**Subject: Request for Supplemental Information, dated June 29, 2001
Sid Larkin & Son, Inc.
Enterprise Recycling and Disposal Facility, Class III Landfill
Pasco County, Florida
Pending Permit Numbers 177982-001-SC and 177982-002-SO**

Kim Ford's Review Comments

John Morris' Review Comments:

TABLE 1 - REVISED
PROPOSED ENTERPRISE RECYCLING AND DISPOSAL FACILITY
DADE CITY, FLORIDA
CALCULATED DILUTION OF POTENTIAL POLLUTANTS

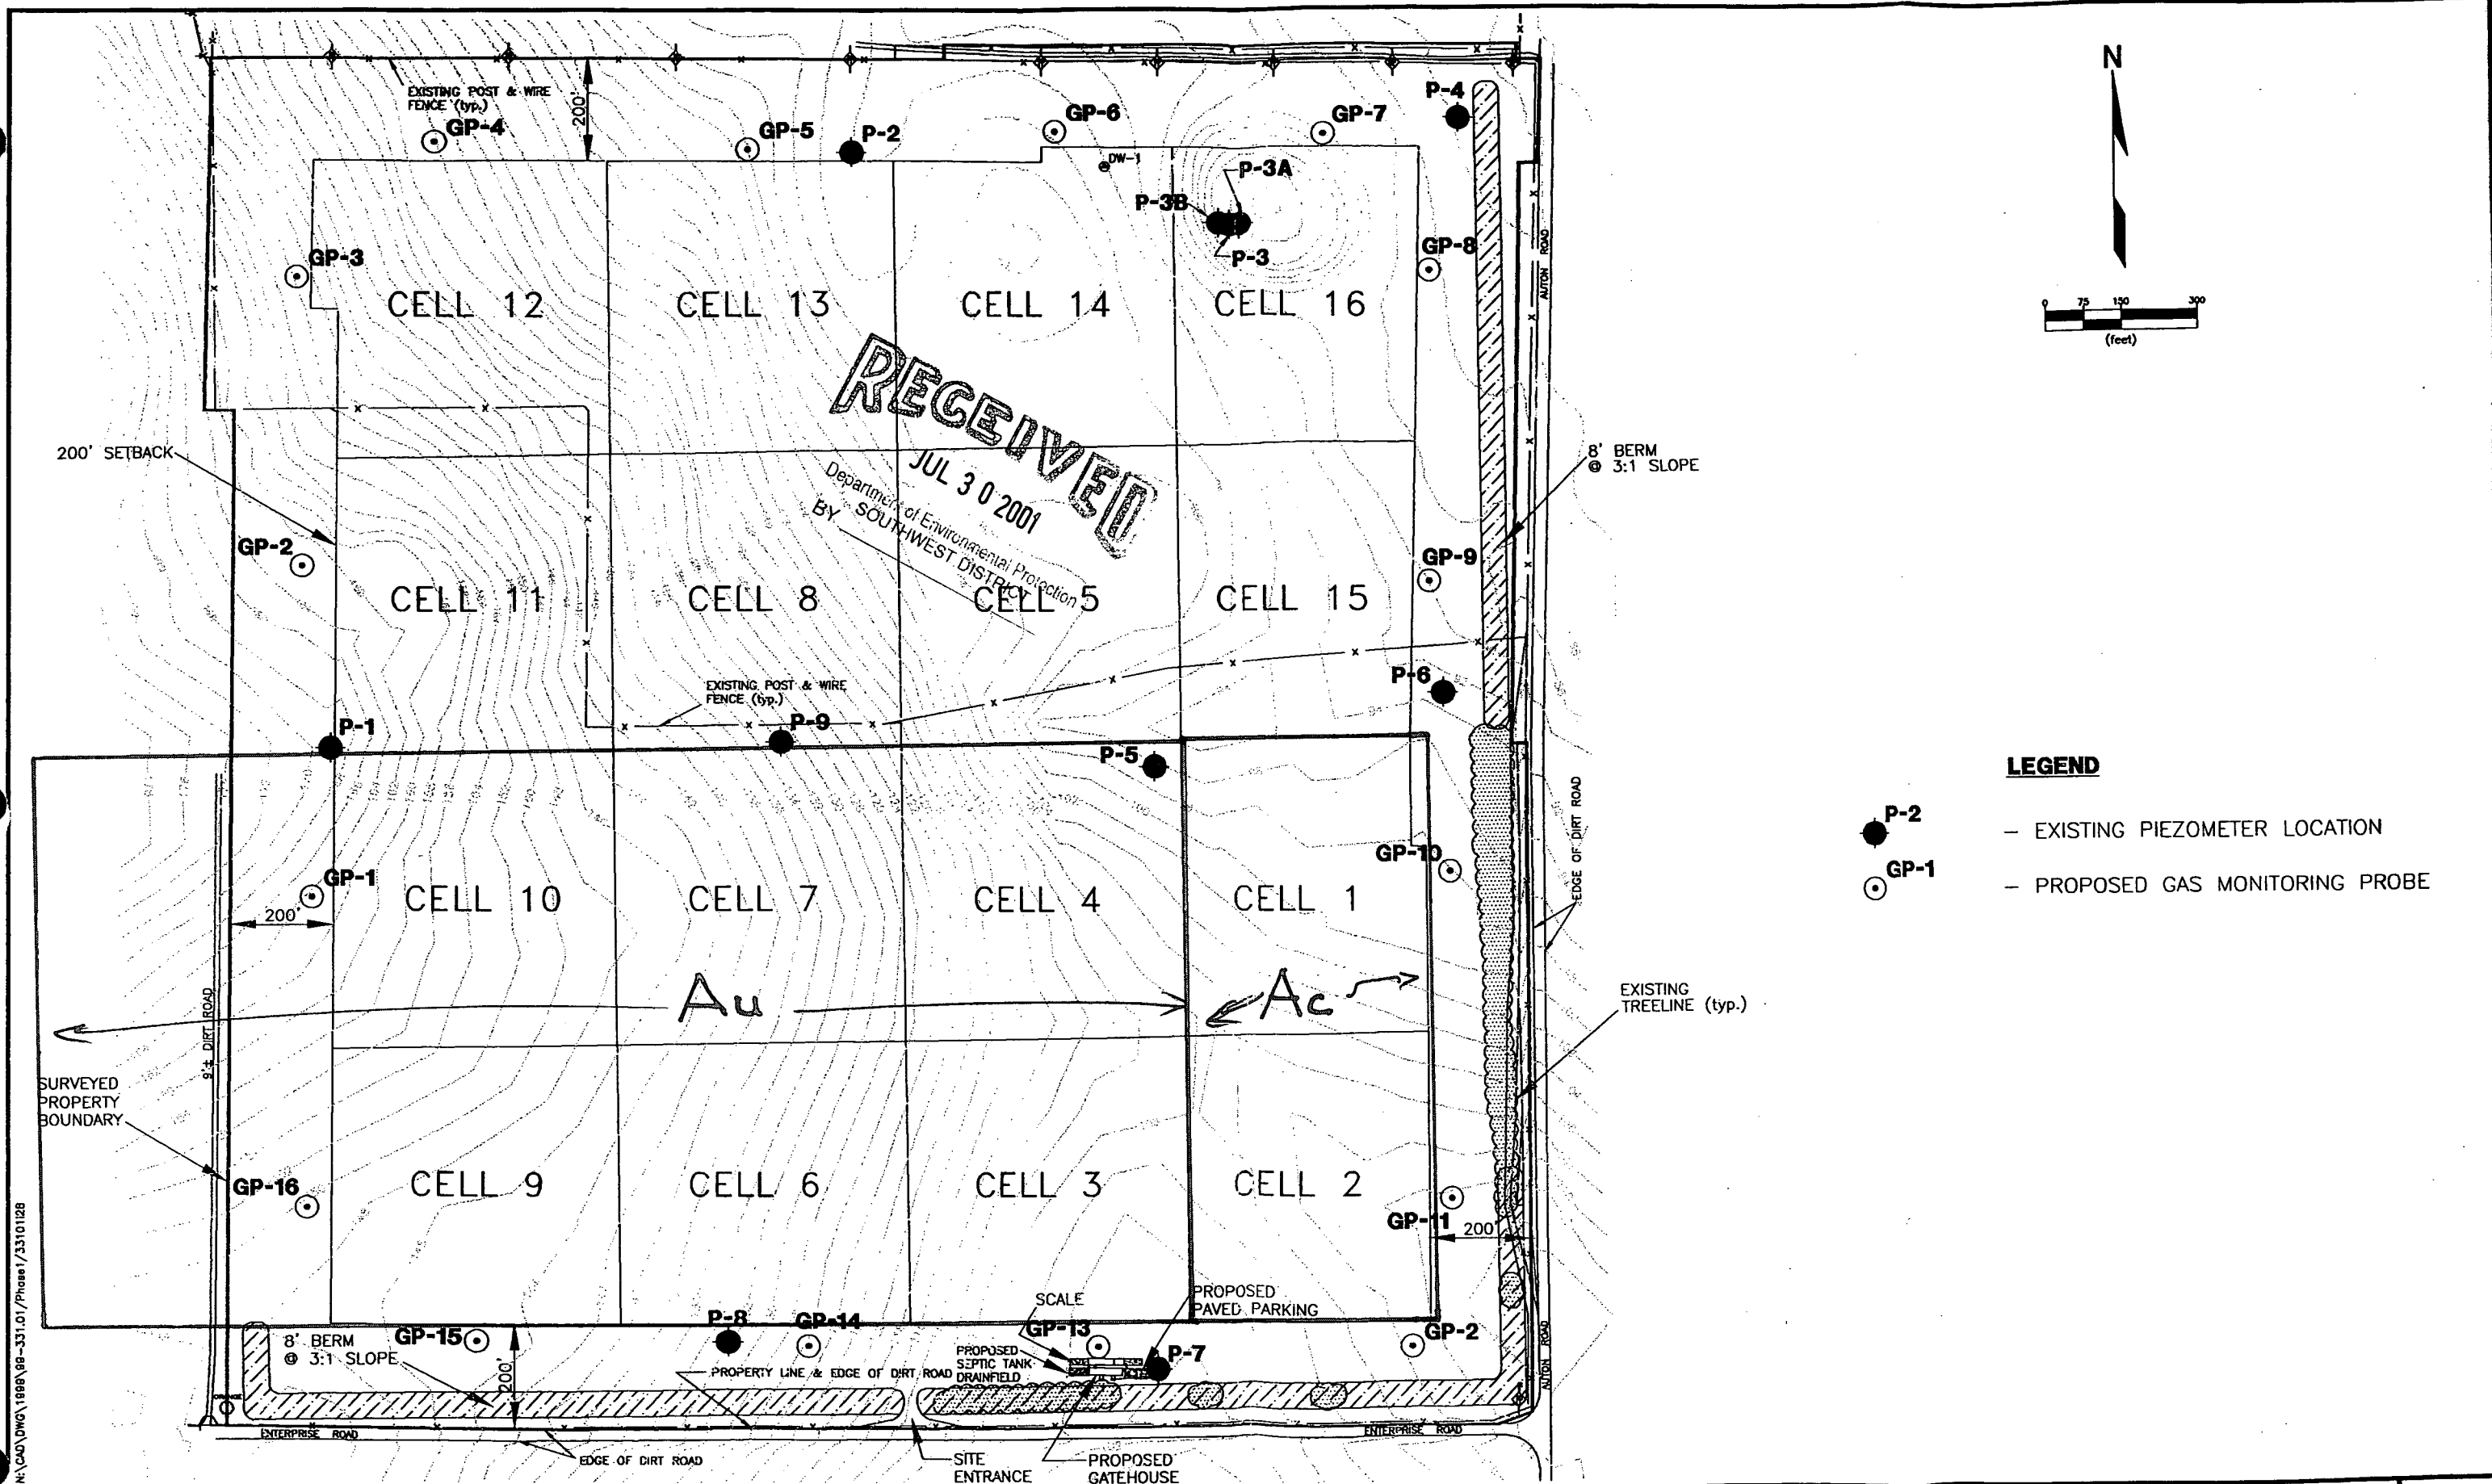
Comment 1d: It is understood that the area of the region upgradient of Cells 1 and 2 that contribute ground water (A_u) was based on topography from quadrangle maps for the vicinity of the subject property. Documentation of the area upgradient of Cells 1 and 2 was not included in the submittal for review.

Comment 1e: The difference in effective porosity between native soils and emplaced wastes is not addressed in the dilution calculation.

Comment 1f: The seasonal variability in hydraulic gradient and direction of ground water flow is not addressed in the dilution calculation.

Comment 1g: The assumption that all potential pollutants are not present in background (C_b) is not considered to be valid. The attached table presents water quality data for surficial aquifer wells located within 50 miles of Dade City that are considered to be more representative of background conditions.

See attached map to document area (A_u) used for calculations upgradient of Cells 1 and 2.

We acknowledge that the porosity variability of the native soils versus the wastes would affect a more complex solute transport equation. However, many other variables, such as soil carbon content, oxygen content and diffusion also can affect the result. So for simplicity, we did not consider porosity variations, or the other variables listed.

We assumed that the surface water, and most of the groundwater, would flow downhill (from approximately 180 ft NGVD to the west to 100 ft NGVD to the east). Again, to keep it simple, we did not include these variables.

Our initial permit submittal included representative background water quality for the surficial and Floridan aquifer in Pasco County, see Appendix 5-H. It is obvious that many of the surficial aquifer wells included on your 50 mile radius list have been impacted by pollution sources. We acknowledge that the upgradient surface and groundwater may not be free from all contaminants, but for the past 75 years the site and uphill areas have only been used for agricultural uses such as orange groves or cattle grazing, not considered significant pollution sources. Basically, the results of our dilution equation can be considered concentrations above background concentrations.

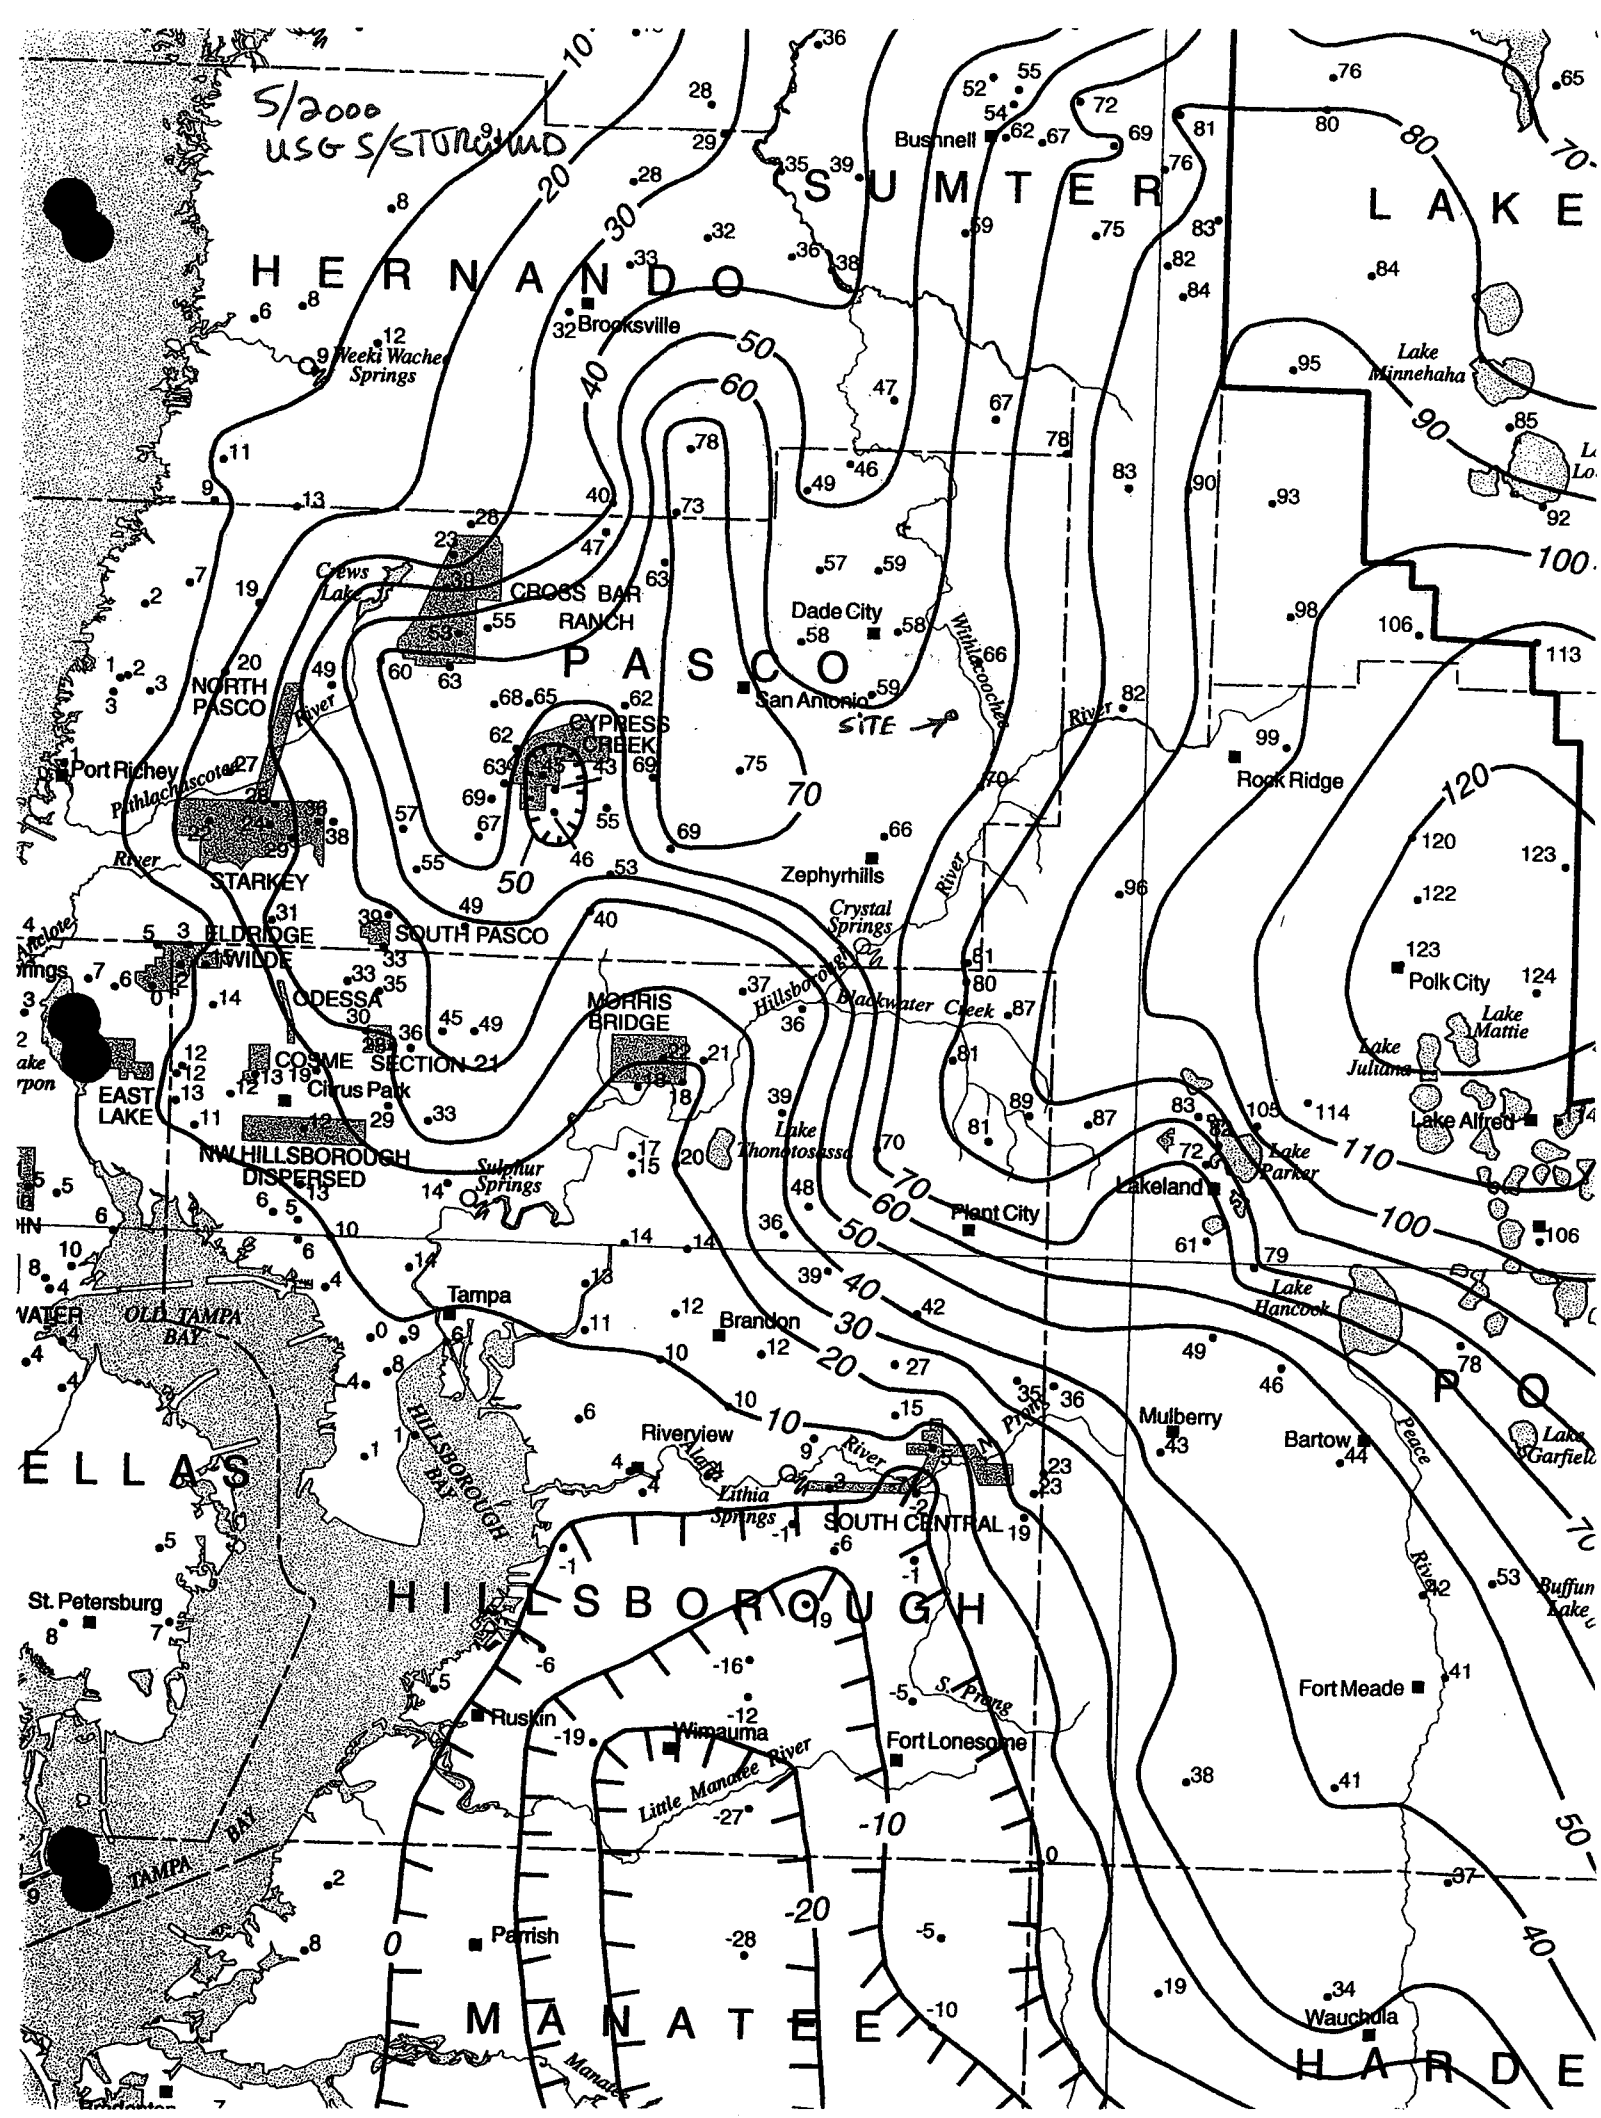
Comment 3. viii. The discussion provided in Submittal 3, regarding anomalous ground water elevations at P-11 is noted. It is also noted that the potentiometric surface contour map provided for water levels measured on May 8, 2001 (Submittal 3, Figure 14.2) incorrectly includes the ground water elevation at P-3A. Revision of Figure 14.2 to exclude data from P-3A will cause substantial changes to the direction of ground water flow.

Response: As correctly suggested, we have excluded the P-3A water level data from Figure 14.2, see the attached revised Figure. This has shifted the Floridan's groundwater flow to the north-northeast, the historically predominant flow direction in the area.
